**Subject:** FW: 100 Cleveland Street, London W1T 6NS  
**Attachments:** 100 Cleveland St[6].pdf; 100 Cleveland St (2)[7].pdf

**From:** Tony Meadows [mailto: ]  
**Sent:** 17 August 2016 18:26  
**To:** Beechook, Cilpa  
**Cc:** Rhodes, Maya; Jean Journade; Giada Vercelli; Valery; Hazelton, Laura; Joe Hutton  
**Subject:** Re: 100 Cleveland Street, London W1T 6NS

Client: **ORIENTAL DRAGON**  
Drawing Title: **PROPOSED FRONT & REAR ELEVATION**

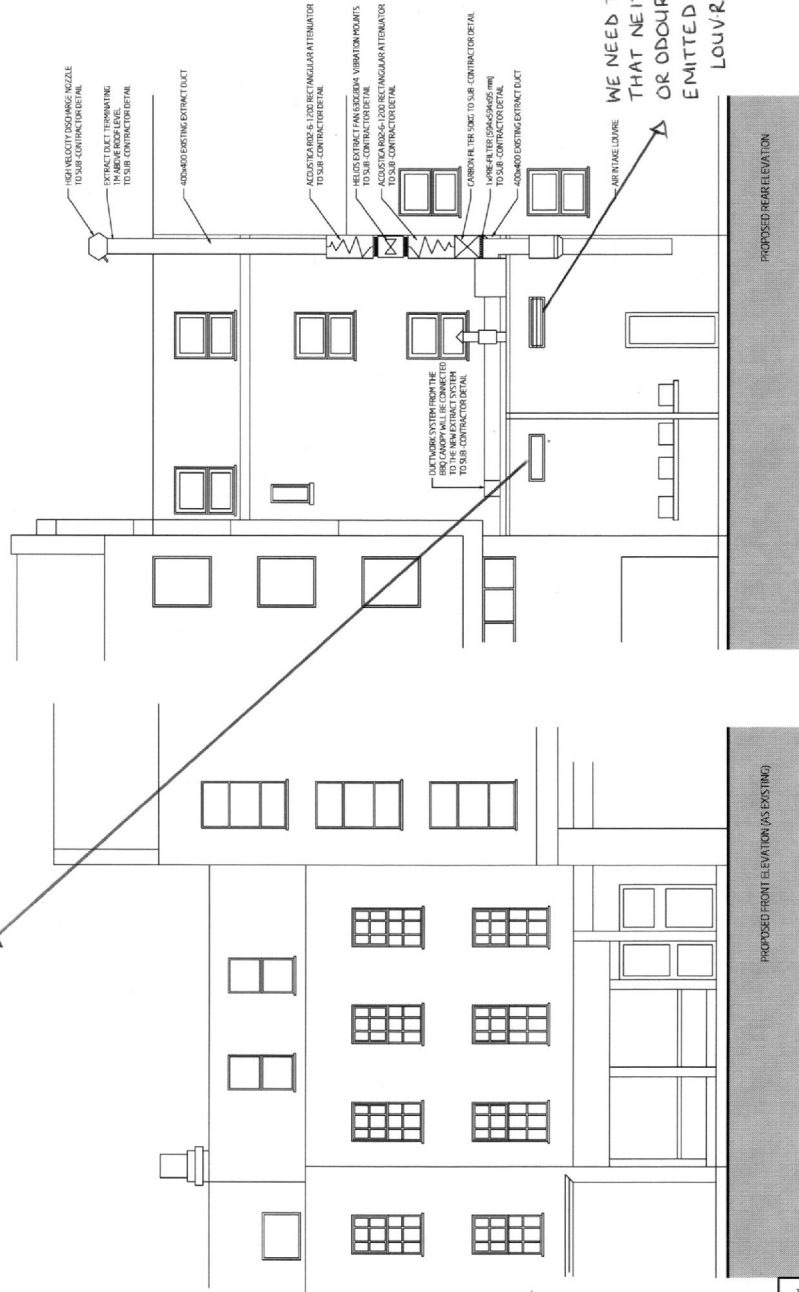
THIS WINDOW IS CONSTANTLY LEFT OPEN AND WE EXPERIENCE BOTH ODOUR AND INTRUSIVE NOISE LEVELS. CAN WE PLEASE ENSURE THAT THIS WINDOW IS CLOSED AT ALL TIMES.

WE NEED TO ENSURE THAT NEITHER NOISE OR ODOUR CAN BE EMITTED FROM THIS LOUVRE WINDOW.

**Project Title**  
PROPOSED ROOF PLAN

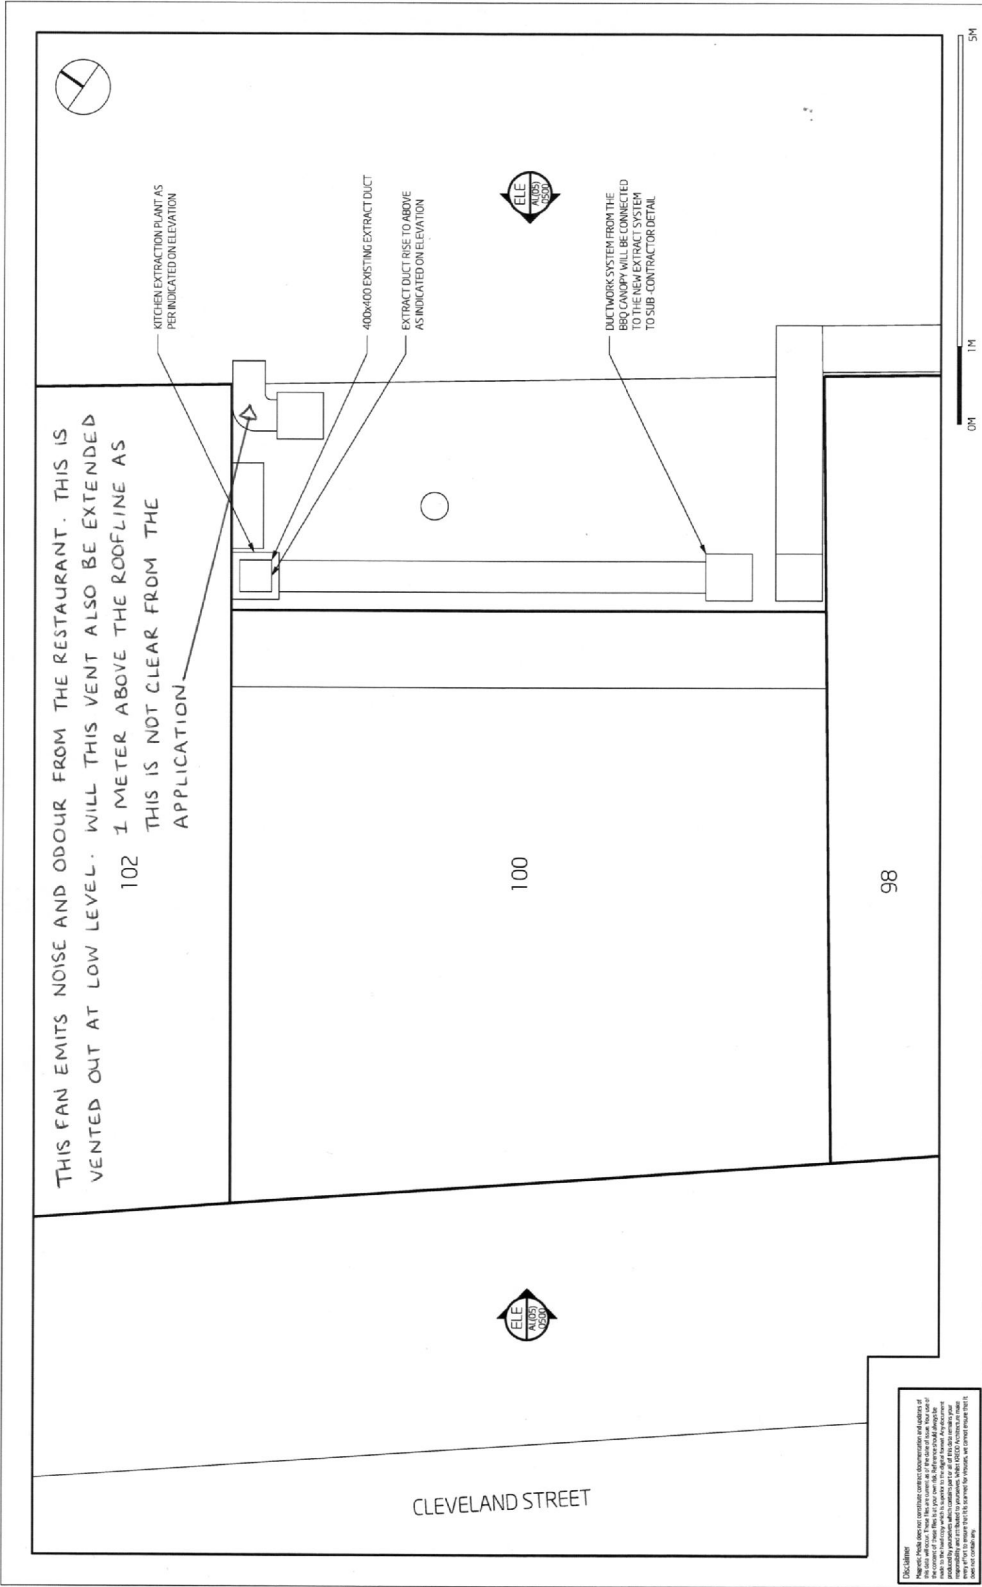
- 1) The '400x400 existing extract duct' attached to the lower face of the building is not included in previous planning permissions, and is a dangerous protrusion into the highway as well as the source of unpleasant odours at low level. This element of the installation should also be addressed and resolved, or removed.

THIS FAN EMITS NOISE AND ODOUR FROM THE RESTAURANT. THIS IS VENTED OUT AT LOW LEVEL. WILL THIS VENT ALSO BE EXTENDED 102 THIS IS NOT CLEAR FROM THE APPLICATION
